### Aquapour Independent Peer Review Findings

#### Princeton Plasma Physics Laboratory

**Subject:** Peer Review of September 8, 2014: Impact of CTD 425 Resin-Contaminated Aquapour on NSTX-U Operations

### Failure criteria

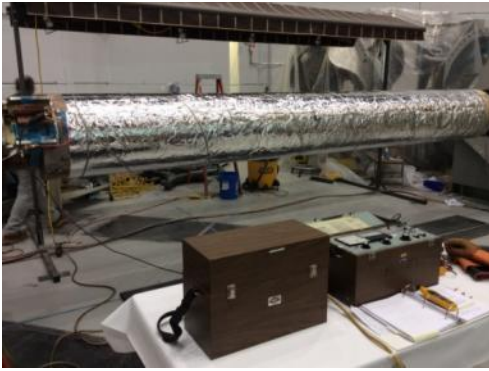
M10. My proper engineering colleagues can comment, but I thought Tresca stress, while recognizing the superposition of shear and compression/tension in a generally appropriate way to represent total stress, did not intrinsically relate this to the loci of allowable shear and tension/compression in a composite material at various temperatures and desired fatigue lives, as Mohr plots do?

*Answer: The failure criteria we generally use are described in the slide below. Mohr’s Circle analysis is used to determine the shear stress in the plane of the composite.*

**Tsai-Wu has been proposed for Composite materials. It is available in ANSYS but we haven’t used it**
